Access Compliance Report

Public Rights-of-Way

Intersection ID: 48369	Main Street: WHEATFIELD_RD	Cross Street: TURKEY_HILL_RD	Location: NE
ADA ID: 981E3FB74400	Ramp Type: PerpDiag	Initial Pass/Fail: Fail	Overall Compliance: No
Severity Score: 21.25			
Codes/Mitigation Info/Possible Solution		Field Measurements/Component Compliance

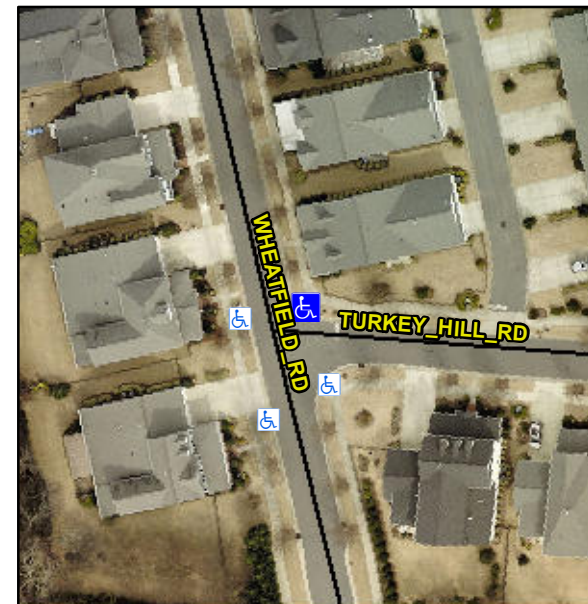
Not Found, R304.5.1, R304.2.2

Compliance	Description	Data	Compliance	Description	Data
N/A	Ramp Length (in)	73.0	No	Ramp Slope (%)	8.6
No	Ramp Width (in)	46.0	Yes	Ramp XSlope (%)	1.0
N/A	Flare Type LT	N/A	N/A	Flare Type RT	N/A
N/A	Flare Slope LT (%)	N/A	N/A	Flare Slope RT (%)	N/A
N/A	Flare Traversable LT?	N/A	N/A	Flare Traversable RT?	N/A
N/A	Landing Length (in)	N/A	N/A	DWS Provided?	N/A
N/A	Landing Width (in)	N/A	N/A	DWS Contrast?	N/A
N/A	Landing Slope (%)	N/A	N/A	DWS Length (in)	N/A
N/A	Landing X Slope (%)	N/A	N/A	DWS Full Width?	N/A
N/A	Landing Curb? (Y/N)	N/A	N/A	DWS Offset (in)	N/A
N/A	Shared Landing?	N/A			
N/A	Gutter Ponding?	N/A	N/A	Gutter Slope (%)	N/A
N/A	Gutter Lip Ht (in)	N/A	N/A	Gutter X Slope (%)	N/A
N/A	Painted X Walk1?	No	N/A	Painted X Walk2?	No
	X Walk 1 Direction	To W		X Walk 2 Direction	To S
N/A	X Walk 1 Width (in)	N/A	N/A	X Walk 2 Width (in)	N/A
	X Walk 1 Slope (%)	1.7		X Walk 2 Slope (%)	0.0
	X Walk 1 X Slope (%)	0.6		X Walk 2 X Slope (%)	0.7

Remove & Replace Curb Ramp With Two New Directional Ramps or Equivalent.
